SITE PLAN APPLICATION

9/13/21 Plan Commission Meeting

Village Planner Report

RE: Murphy Project Site at W206N12880 Gateway Court; Site Plan Review Application
Staff Review Comments

SITE EROSION CONTROL PLAN C4.0

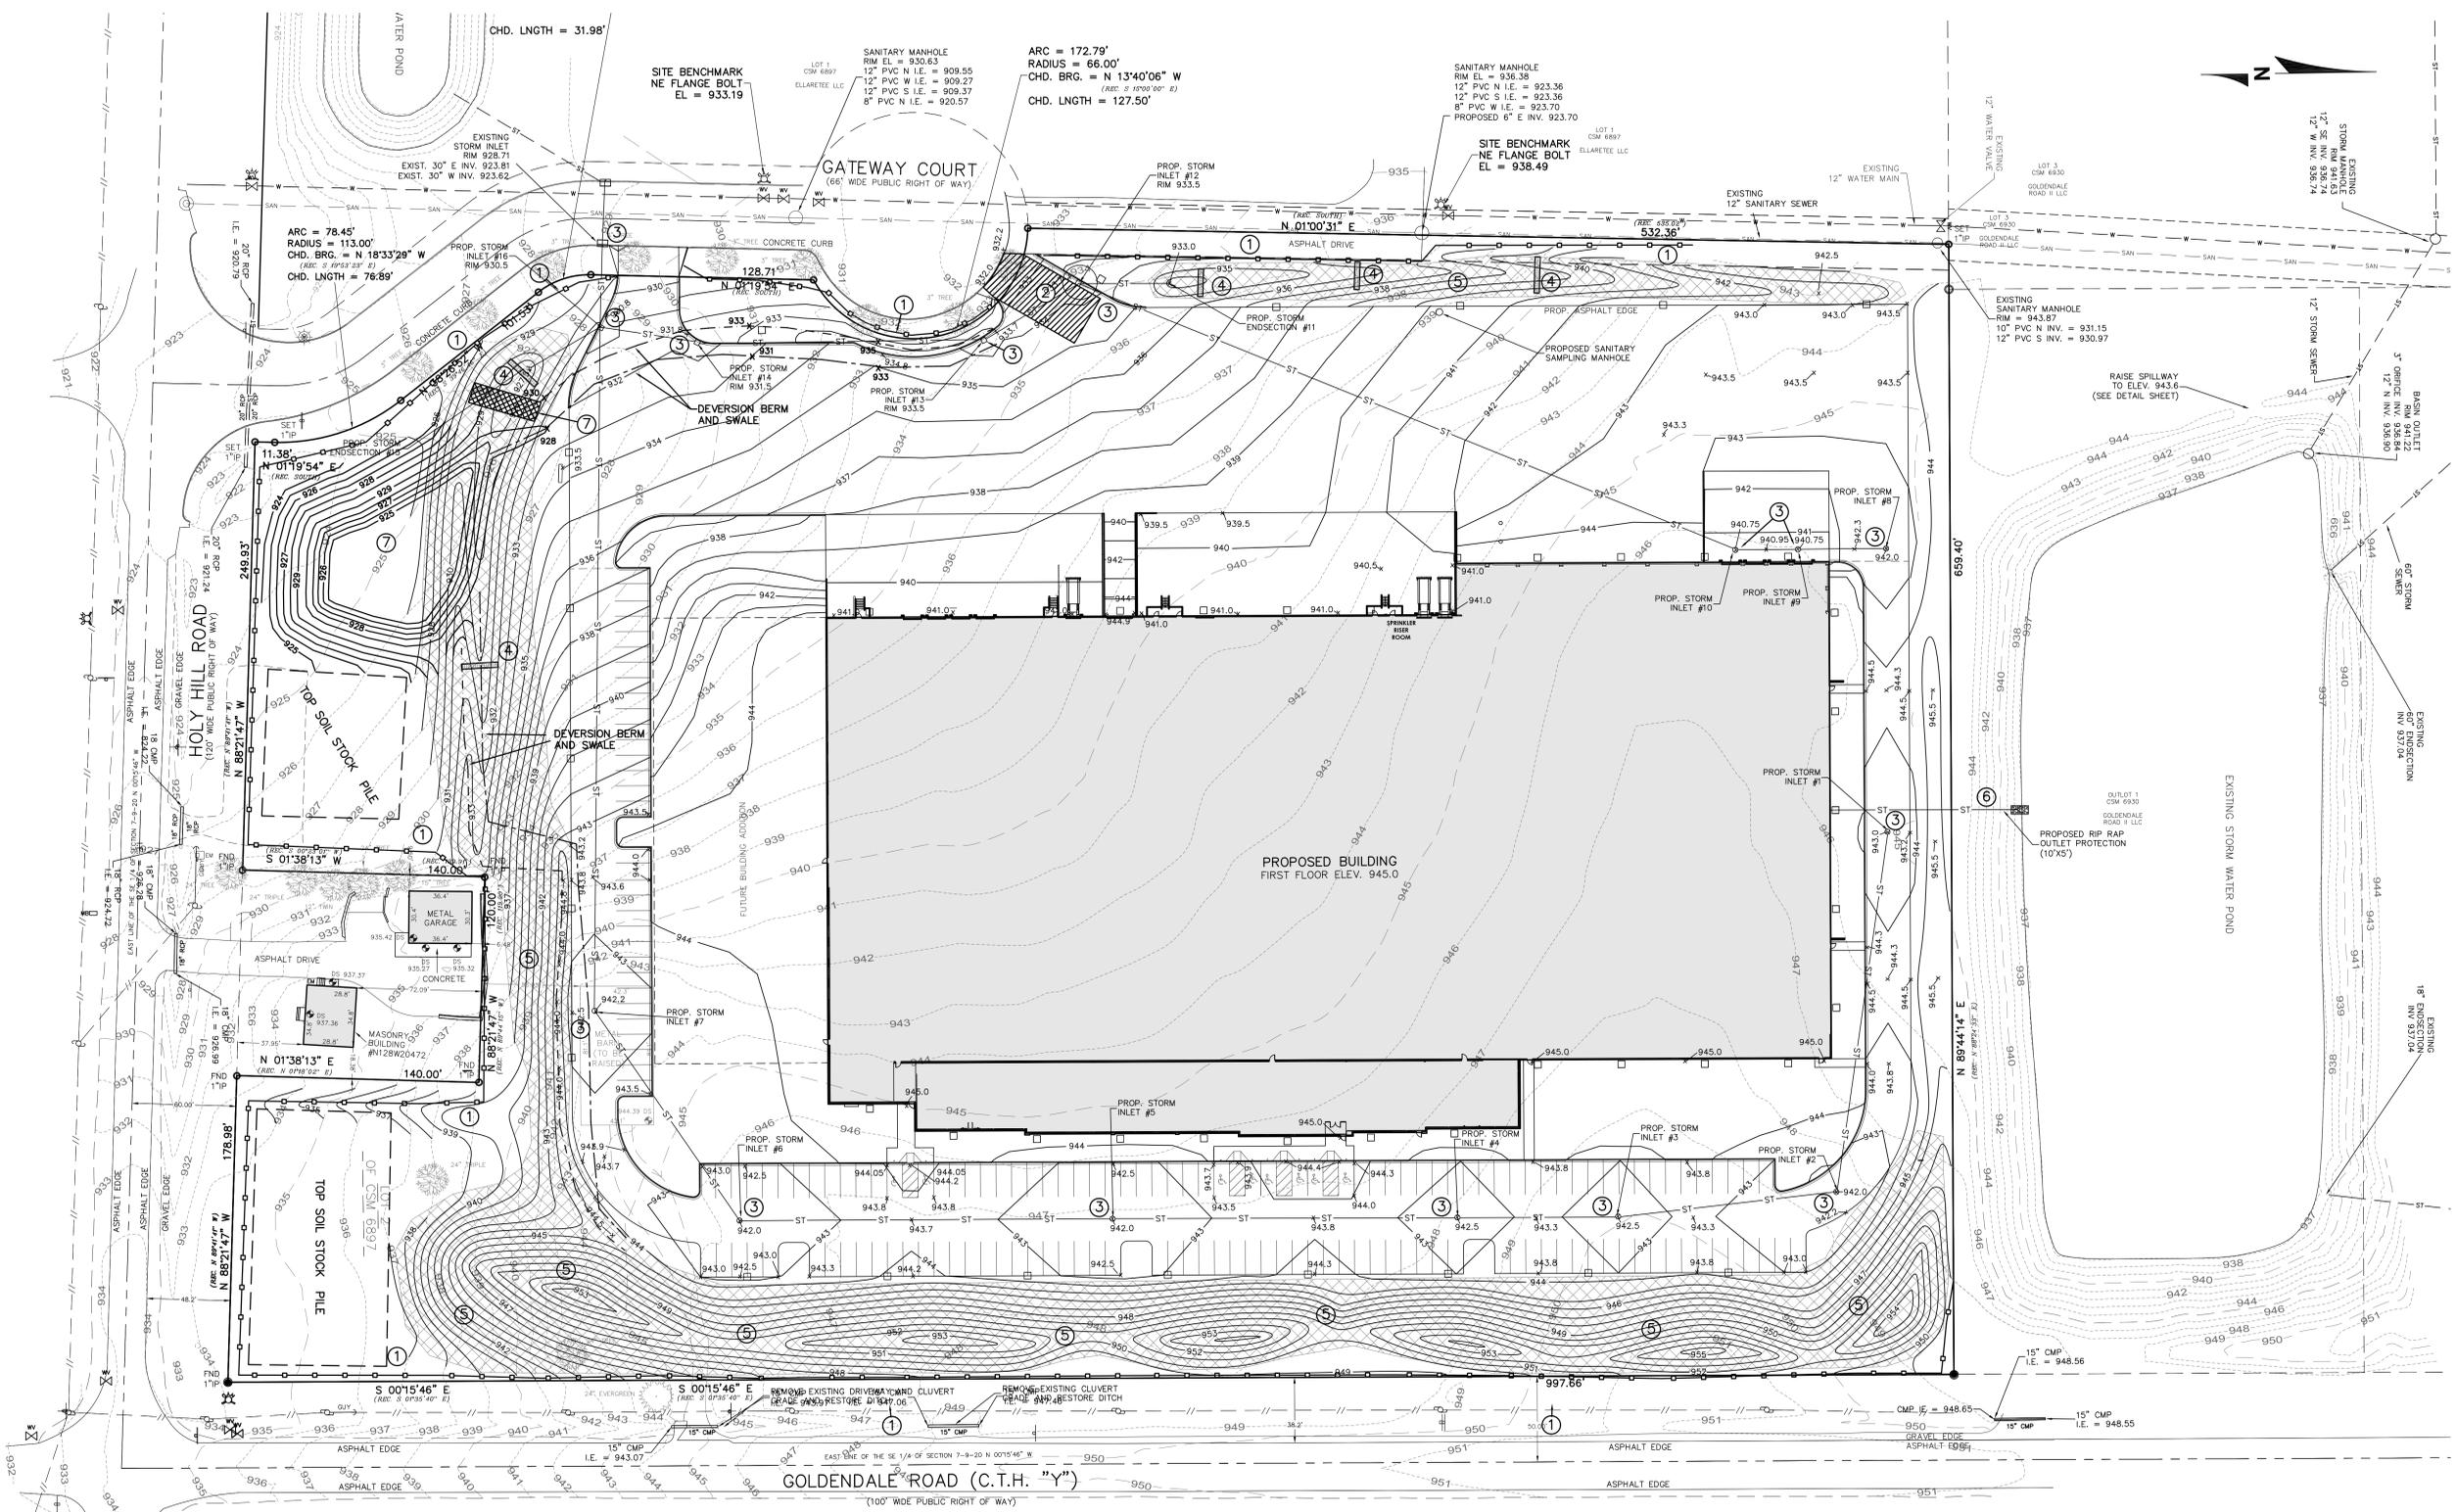
C4.0 Erosion Control Plan

1. Existing stormwater basins shall not be used as sediment traps. Provide on-site sediment traps meeting WDNR technical standards. Show how runoff will be routed through the basins during construction.
A sediment trap has been added to the plans in the SW corner. Diversion swales and berms are shown on the plan to direct the runoff to the trap during construction.
2. Graphically show areas requiring erosion matting and specify the type of matting to be used.
The location and type of matting has been added to the plan
3. Silt fence is not an appropriate means of erosion control at areas of concentrated flow
Understood. Hay Bale ditch checks and a sediment trap are being used in the areas of concentrated flow.

L1.0

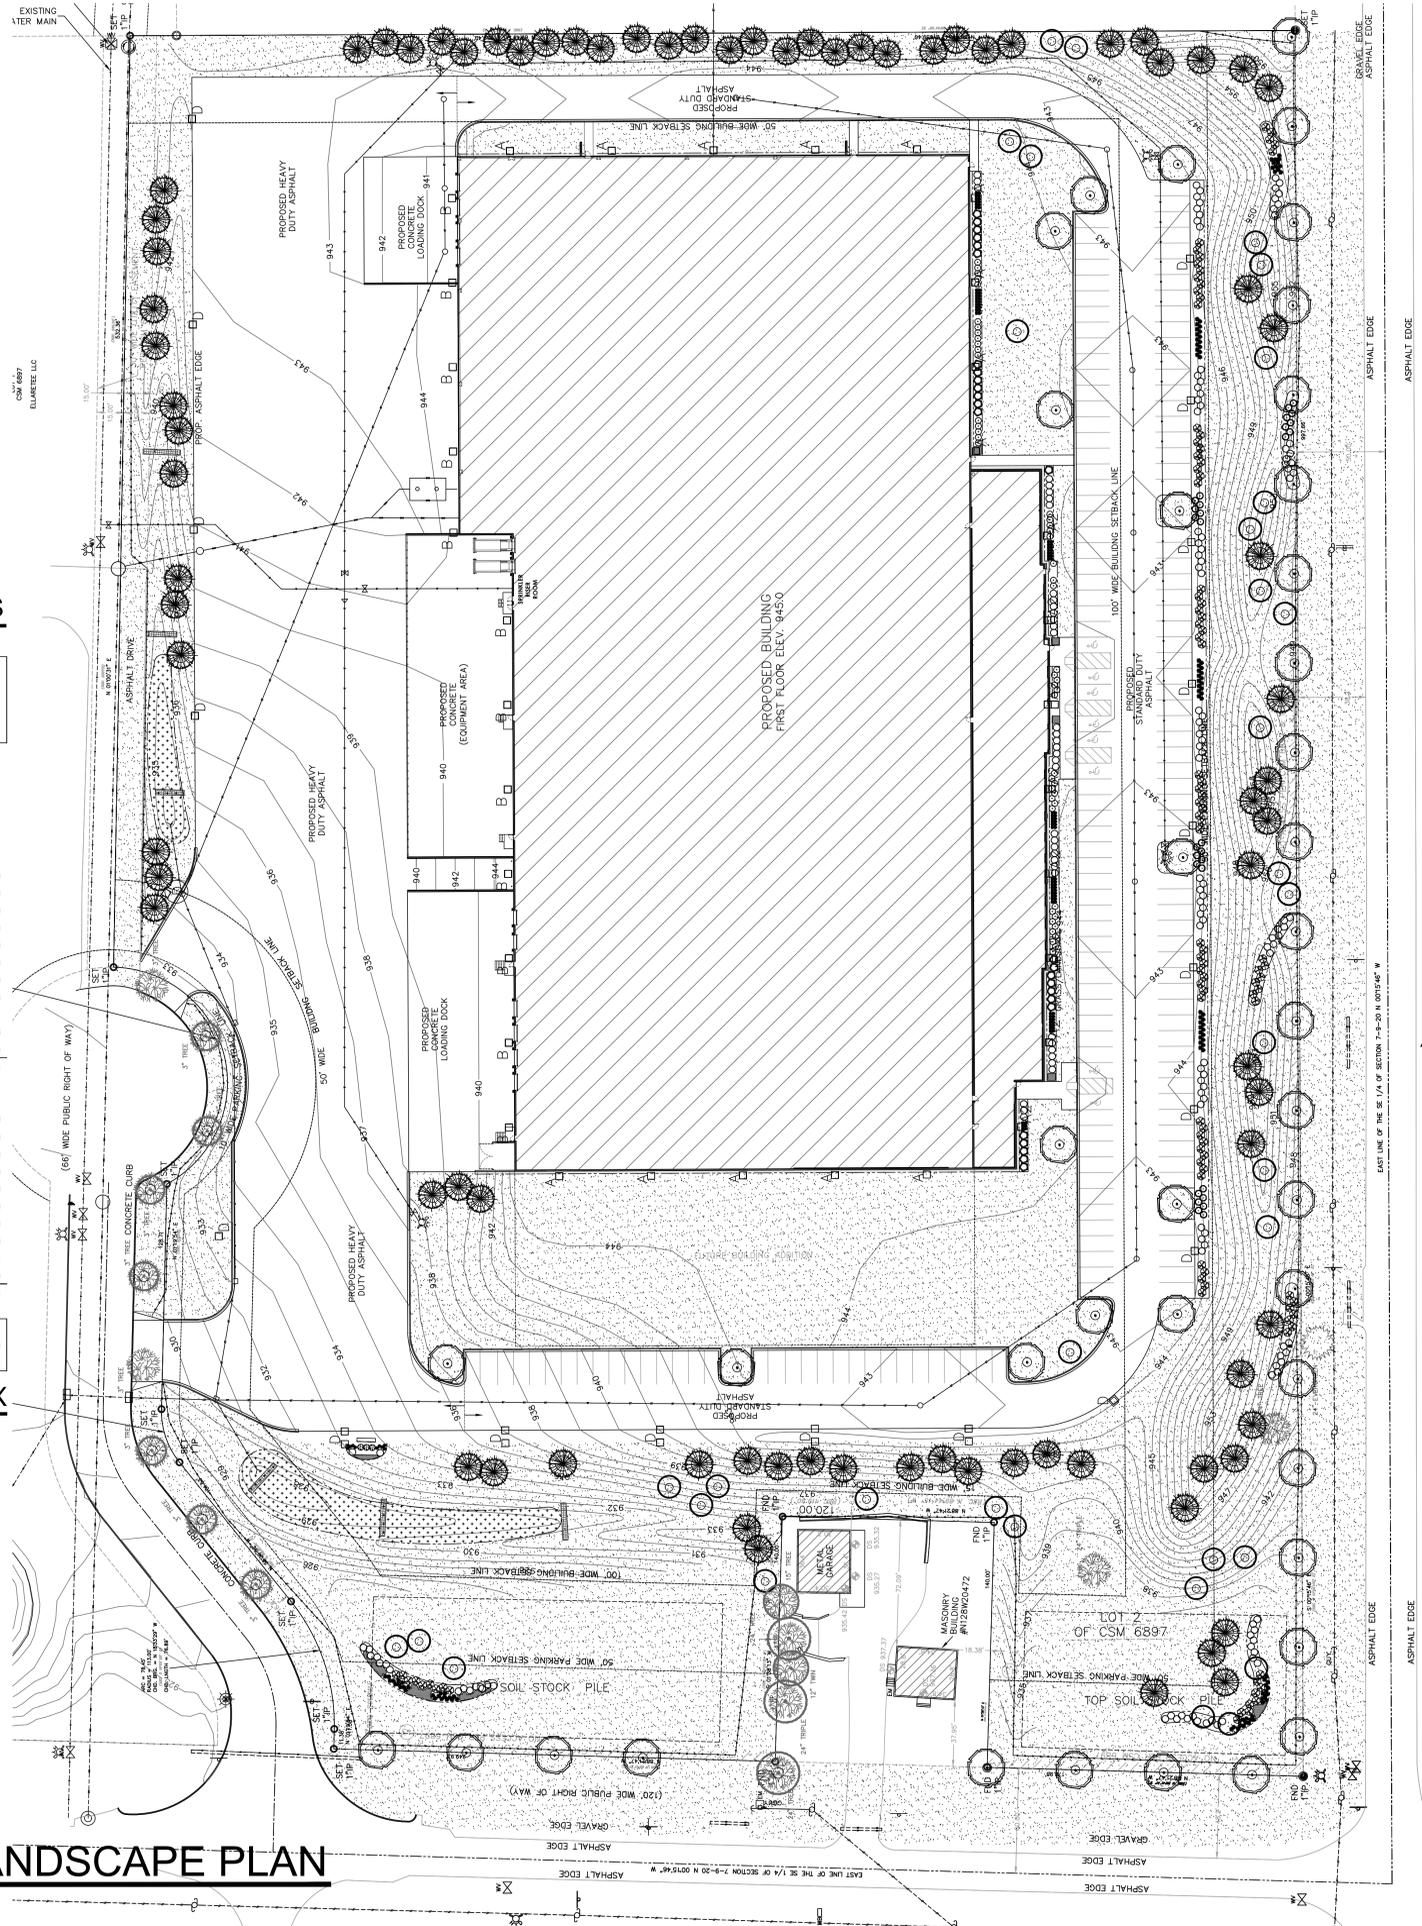
The Village Forester reviewed the landscape plan and has requested that details on protective fencing for the trees/shrubs to be preserved be added to the landscape plan.

4. The two street trees to be removed for the driveway accesses off of Gateway Court shall be moved or replaced with equivalent sized trees on the property. A revised landscape plan shall be submitted for review and approval by the Village Planner.

All deciduous trees shall be a minimum of 2" caliper. This information should be added to the Landscape Plan. **All deciduous trees shall be a minimum of 2" caliper as required and is reflected on landscape plan. All shade trees on landscape plan are specified above the minimum requirements and are 2.5" caliper. All deciduous ornamental trees are specified as multi-stemmed at 7-8 feet high which is equivalent to a 2.5-3.0" deciduous tree. Many flowering ornamental trees are grown and sold as multi-stemmed for more visual interest and structure.**

SITE LINE FROM GOLDENDALE ROAD
SCALE: 1/16" = 1'-0"

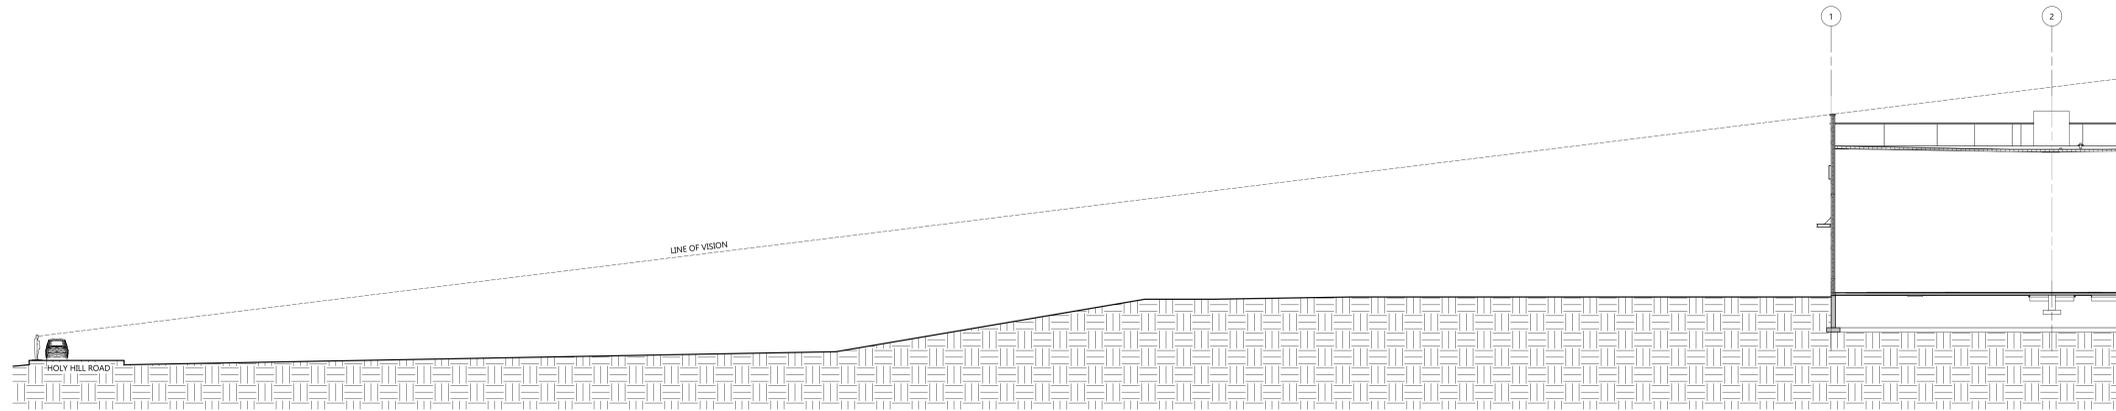
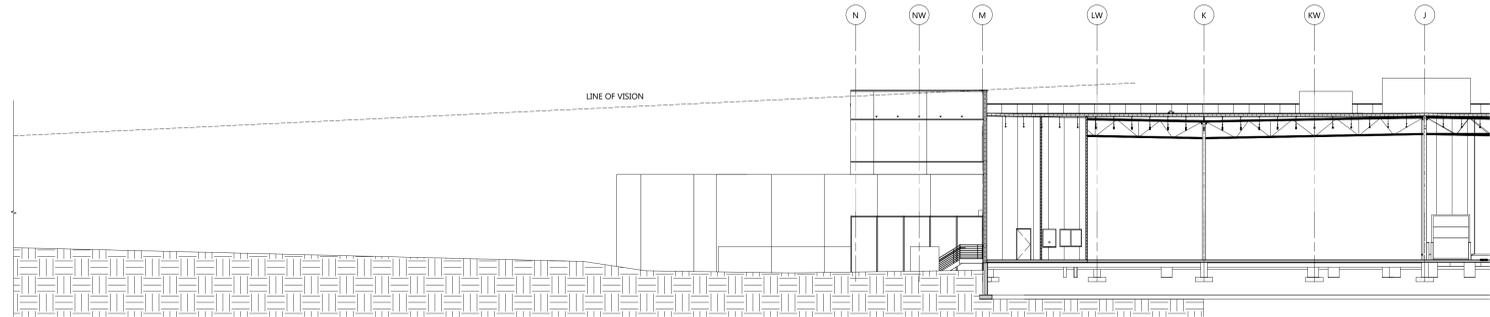
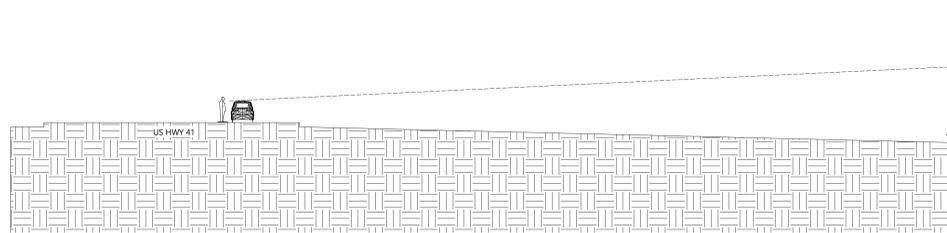
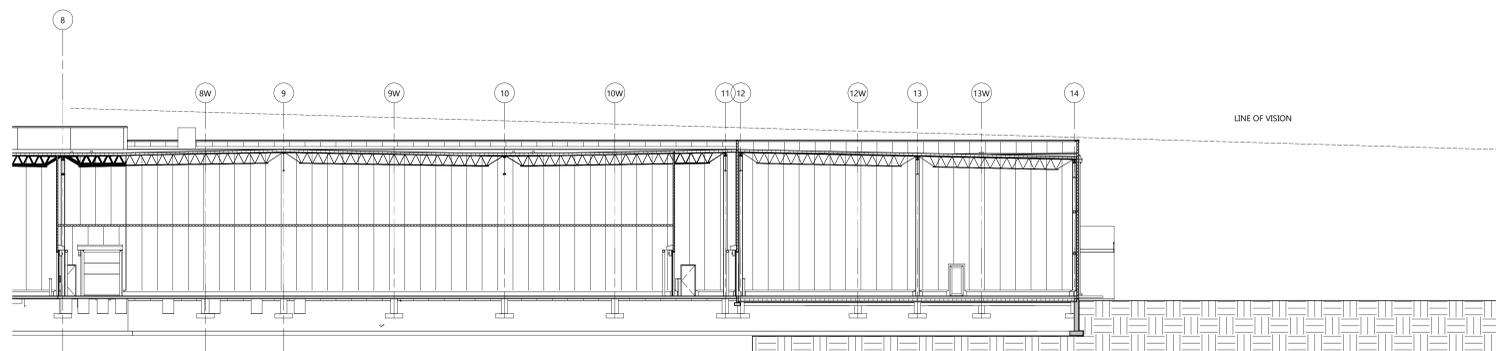
The applicant has provided sight line drawings showing that the proposed roof top units cannot be seen from Holy Hill or Goldendale Roads. The tallest of the rooftop units shown in these diagrams is 8 feet. If the actual height of the rooftop units is higher than the assumed height in the diagram, additional screening of the units from or along the nearest roadways will be required. This has been added as a condition of approval.

5. If the actual height of any roof top units exceeds the height of those shown on the diagram, a revised screening plan and sight line diagrams shall be submitted to the Village Planner for review and approval. Additional screening measures may be required.

10. Following the determination of the location of the refrigeration system (i.e. roof or ground), an updated site plan showing proposed screening shall be submitted for review and approval by the Plan Commission. **We addressed this as well with screening that blends in with the building architecture and still works toward the proper functionality of the equipment. We are intending to not add any major roof top equipment elements for the freezer refrigeration. Most of the refrigeration equipment will be ground mounted. The RTUs will not be visible from any direction. We have provided line of site views for all four sides to illustrate this.**
